**TECHNICAL EVALUATION REPORT
CHRISTENSEN RANCH MINE UNITS 2 THROUGH 6 RESTORATION REPORT
URANIUM ONE USA, INC., WILLOW CREEK ISR FACILITY**

DATE: October 23, 2012

DOCKET NO.: 040-08502

SITE: Willow Creek Christensen Ranch, Wyoming

Figure 3c. MU2 North and South Radium-226 Stability Monitoring Trend Analysis

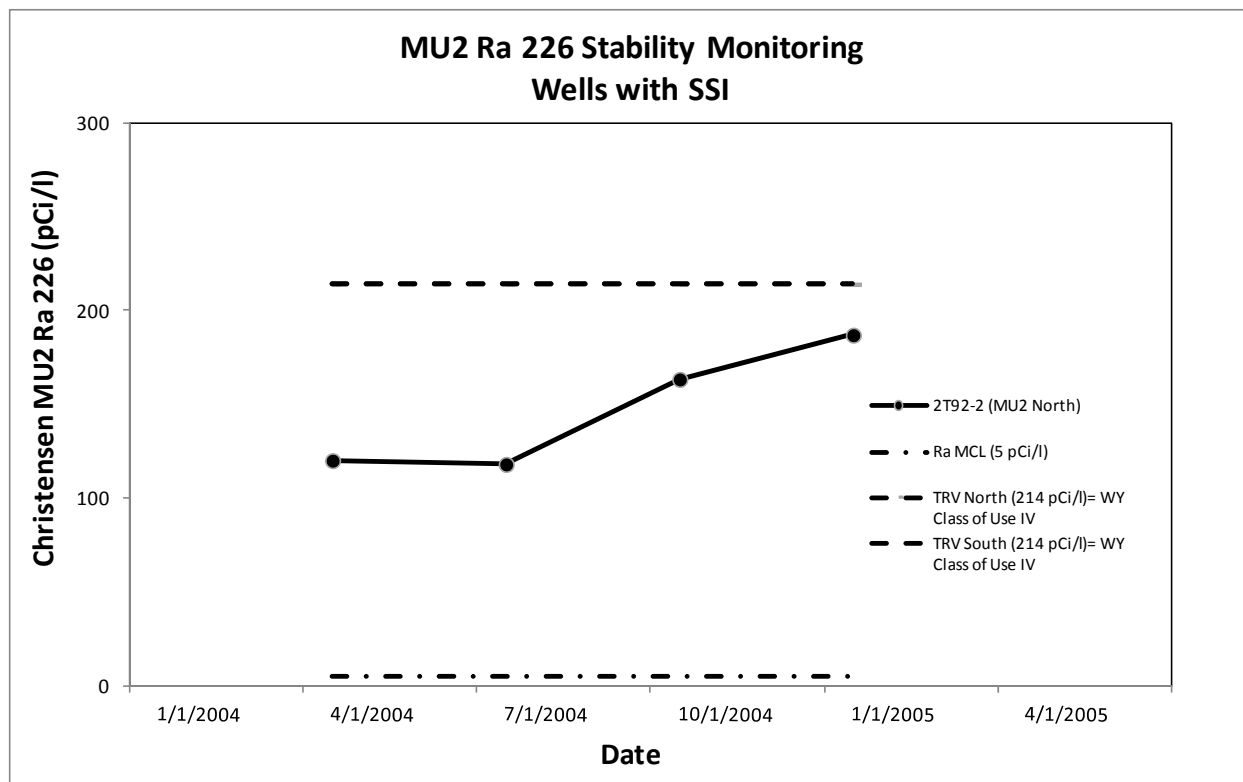
The SSI trend for Mine Unit 2 South for uranium in this well is shown in Figure 3c. It is of concern to the staff because it shows that uranium in this well is above the Class IV standard (background TRV) and is increasing.

- (1) Demonstrate that the SSI trends for uranium and radium-226 at well 2T92-2 are reversed and stable.
- (2) Provide a confirmatory analysis of the groundwater quality at well 2MW108 subsequent to the corrective actions for the 2011 excursion that demonstrates impacts to the aquifer following the 2011 excursion event meet regulatory requirements (groundwater protection criteria).

Figure 4b. MU3 Uranium Stability Monitoring Trend Analysis

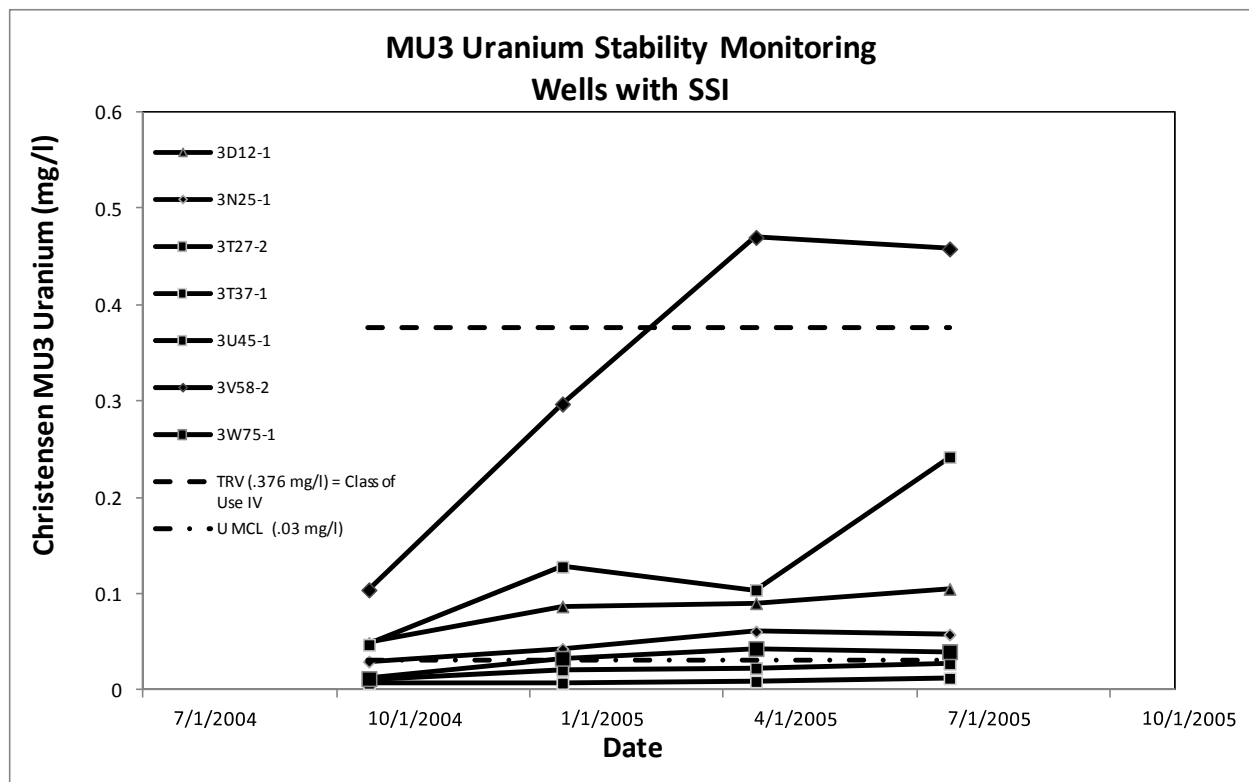
The SSI trend in uranium in two of these wells is of particular concern because one, 3V58-2, has already exceeded the Class IV standard (baseline mean) of 0.0376 mg/l, and another, 3W75-1, has the potential to exceed it. The SSI trend in radium-226 is also of concern because wells 3W75-1 and 3Z87-1, also show potential to exceed the baseline mean Class IV standard of 270.8 pCi/L. The SSI trends in TDS in wells 3AC82-1, 3W75-1 and 3Z87-1 are not of concern because, although they are significantly increasing and are exceeding the TRV, they are far below the WY Class IV standard (Class I, II, III or background TRV) which the staff chose to set at Class II (2000 mg/l).

- (1) Confirm that the well 3D12-2 used in the restoration, but not in the baseline, was needed to replace a well that has been abandoned;
- (2) Demonstrate that the elevated conductivity noted in the 2009 sampling event does not result in levels of all constituents of concern in wells 3T37-2 and 3T27-2 above the applicable standards.
- (3) Demonstrate that the SSI trend noted in the uranium concentrations at well 3V58-2 is reversed and stable.
